County of Fairfax, Virginia

Re: Interpretation for RZ/FDP 2003-DR-049, Rosewood Building and Development LLC, Tax Map Parcel 30-4 ((1)) 3, 3A, 4, 5, 5A, and 6: Lots 8-13, Building Footprints

RE: McLean Cove
LDC Project #01018-1-0

Re: Proffer Interpretation Request – Additional Information
McLean Cove
RZ 2003-DR-049
LDC Project #01018-1-0

APPROVED BUILDING ENVELOPE
EXHIBIT
PER 1286-SP-03-2
SCALE: 1" = 20'
DATE: 01-14-2008

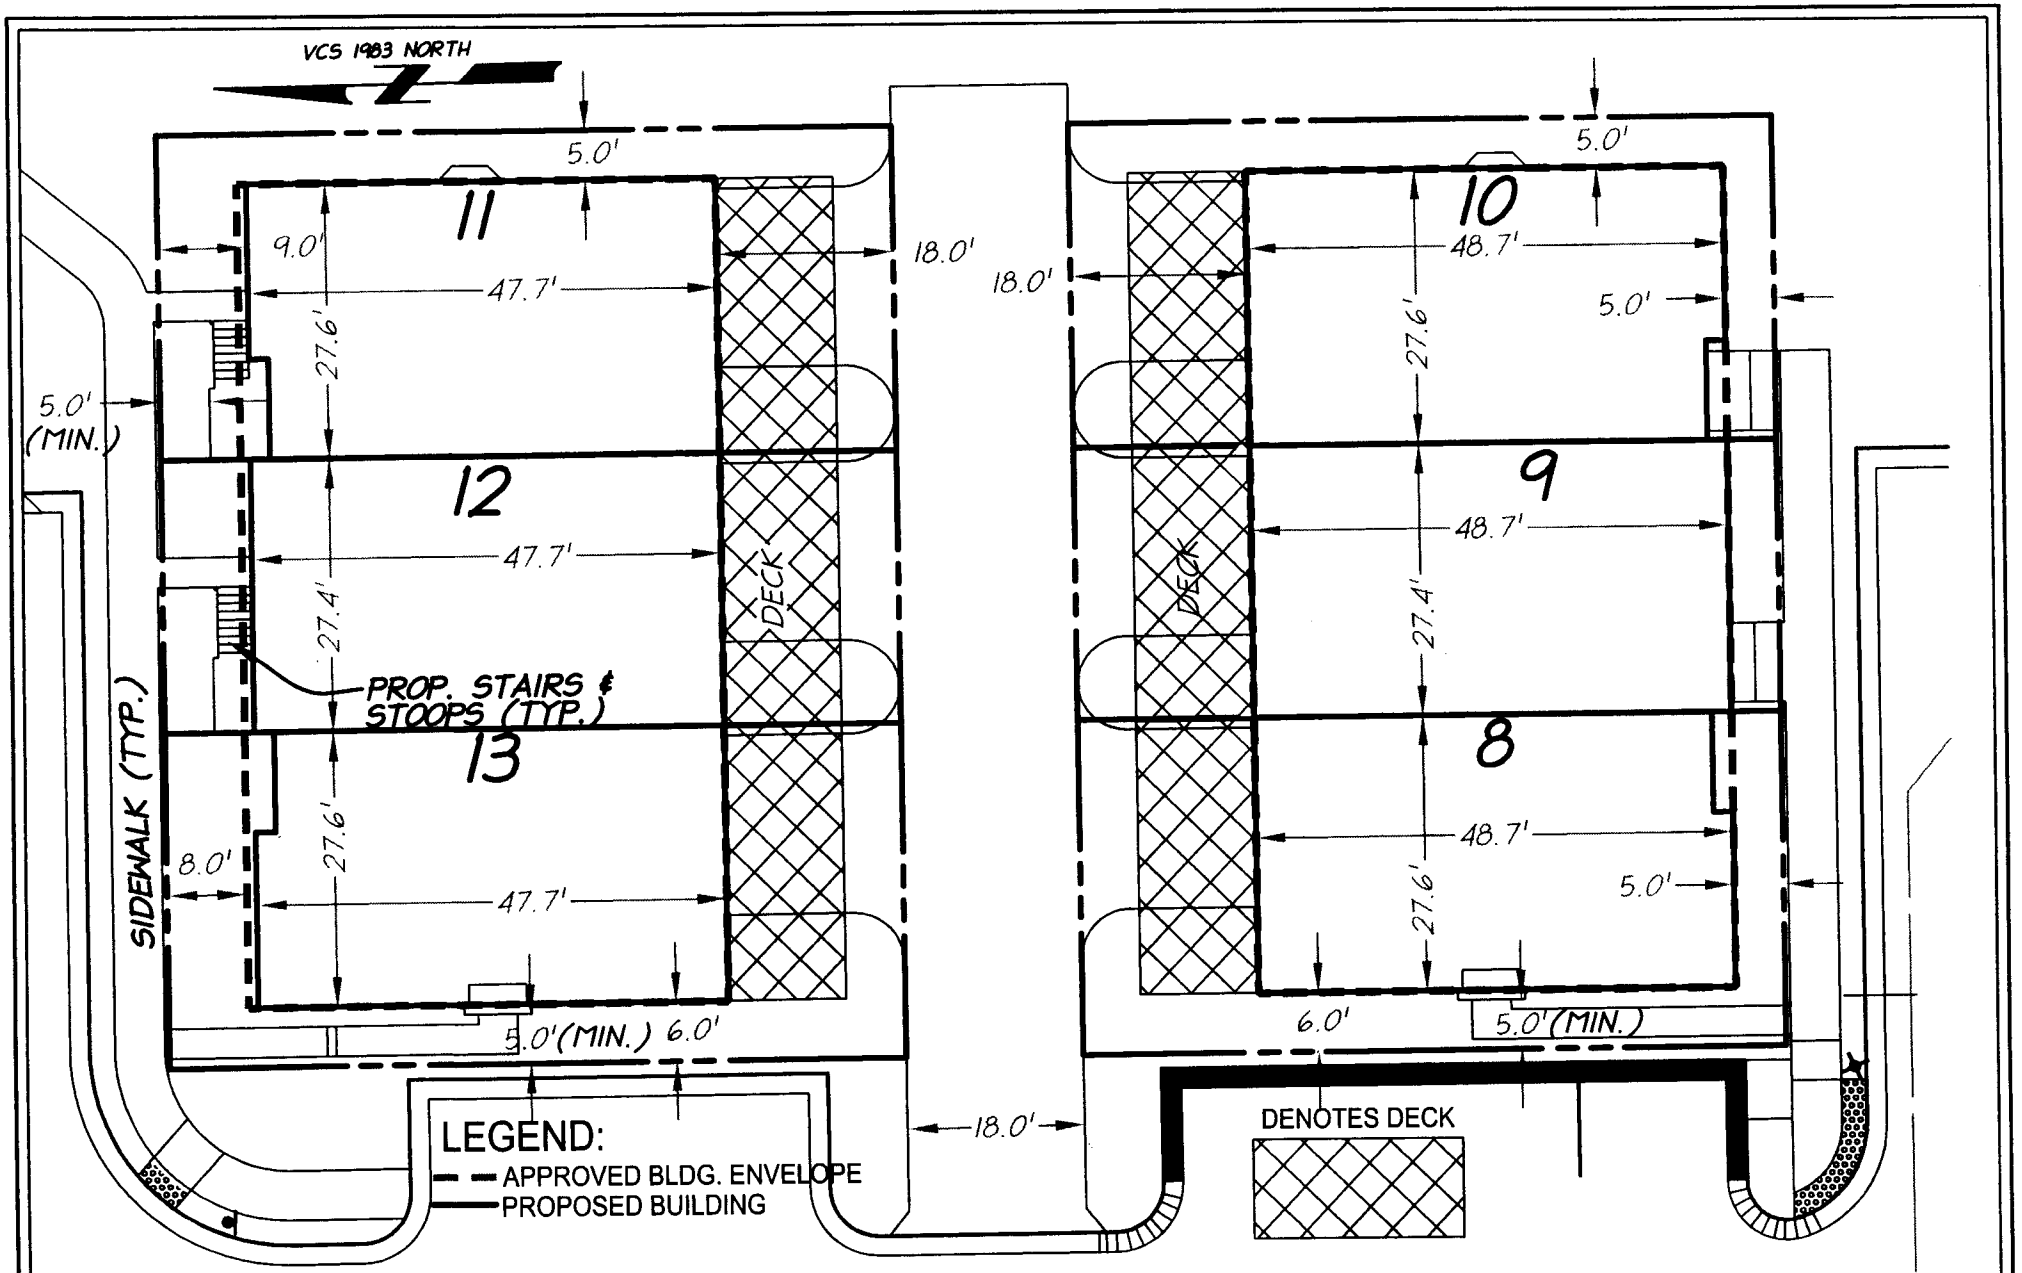
The architect has revised the architectural plans and elevations for Lots 11 and 12 to show the reduction of the depth of the units of Lots 11-13 from 48.7' to 47.7'. As a result, the stairs and stoops on Lots 11 and 12 are now located a minimum of 5' from the property line instead of 4'. As a result, the previously submitted "Approved Building Envelope Exhibit" has been revised and is included for your reference.

As you can see on the "Approved Redline Building Envelope Exhibit", LDC has shown the approved building envelope, not the actual units, (per the approved Conceptual/Final Development Plan (C/FDP)) with a dark, dashed line. Underneath this line is a red line, which illustrates the proposed building. As you can see, the proposed buildings on lots 8-13 are within the approved building envelope and meet the setback requirements, even with the depth increase of 4% (to 48.7'). In addition, the proposed units are staggered along the front in accordance with the approved C/FDP. On the approved C/FDP, the rears of the proposed units are shown as staggering. The final architecturals and site plan do not account for a jog in the rear of the units; however LDC believes this is in substantial conformance with the approved C/FDP and Zoning Ordinance as discussed in detail below.

As you can see, the front of the proposed units on four of the lots have a 2' building jog; however the rears of all of the units have no jog. Since the Applicant is proposing no more than three units in a row, the proposed units (with and without jogs as shown) are in accordance with the Zoning Ordinance.

It is my determination that the proposed building footprints on Lots 8-13 would be in substantial conformance with the CDP/FDP, the proffers, and development conditions for RZ/FDP 2003-DR-049 as long as the minimum required yards are provided and the rear facades are constructed with differing brick colors. This determination has been made in my capacity as the duly authorized agent of the Zoning Administrator and addresses only the questions discussed and defined above. If you have questions, please call Mary Ann Godfrey at 703-324-1290.

PLAN TYPE A LOT 11

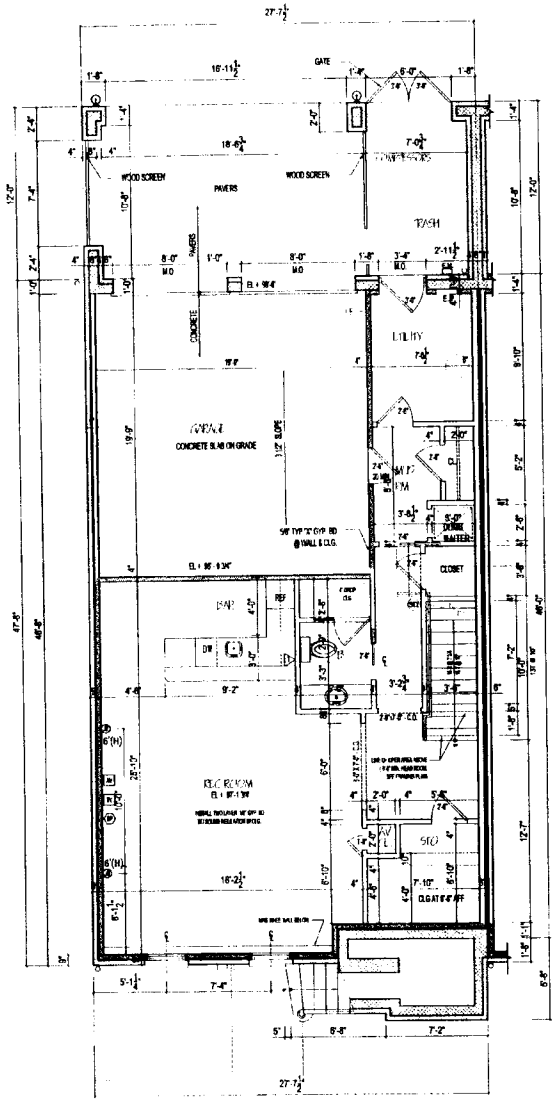
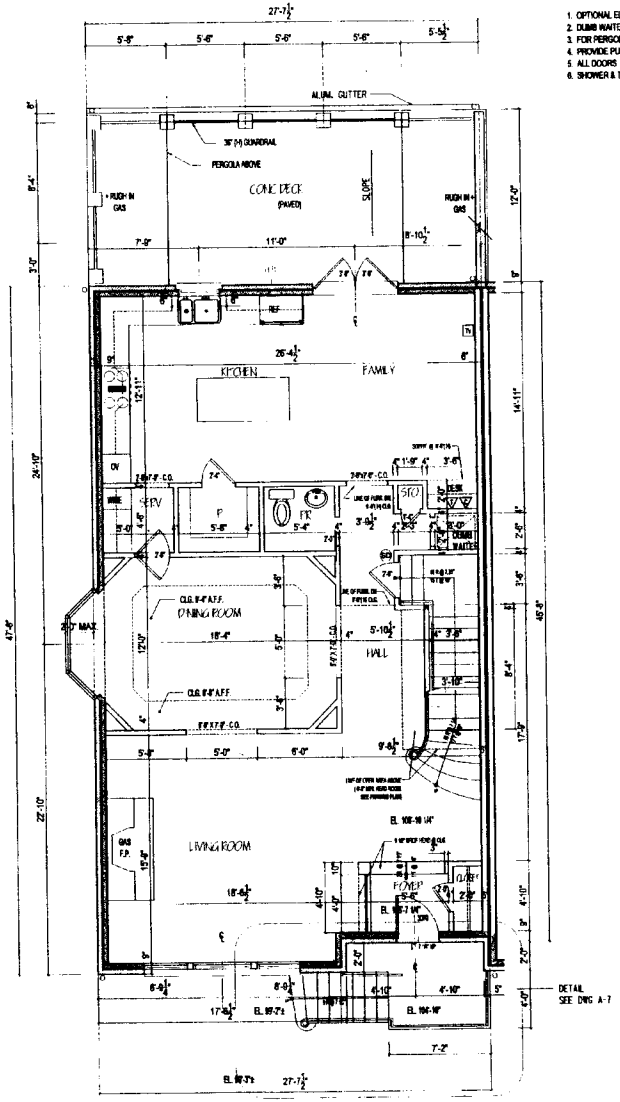
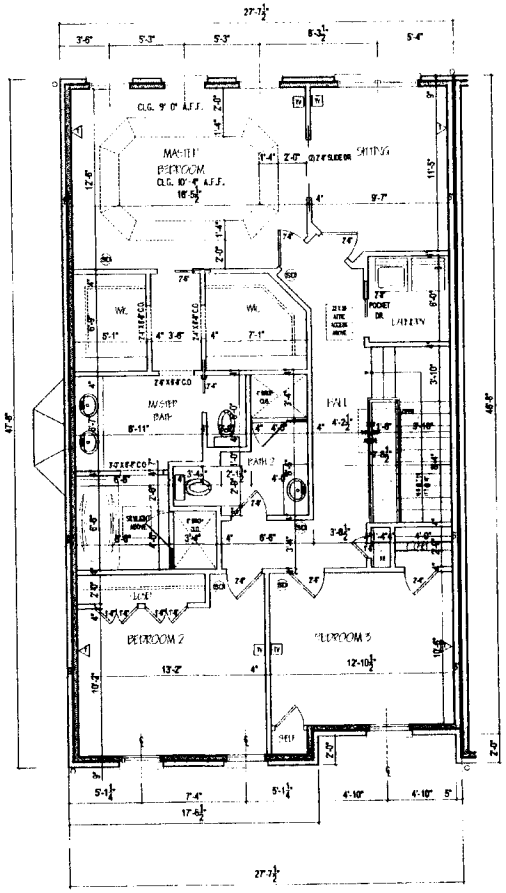
As per your request, the 'Approved Building Envelope Exhibit", architectural plans and building elevations for Lots 11 and 12 have been revised to reflect no encroachment of the stoop and stairs.
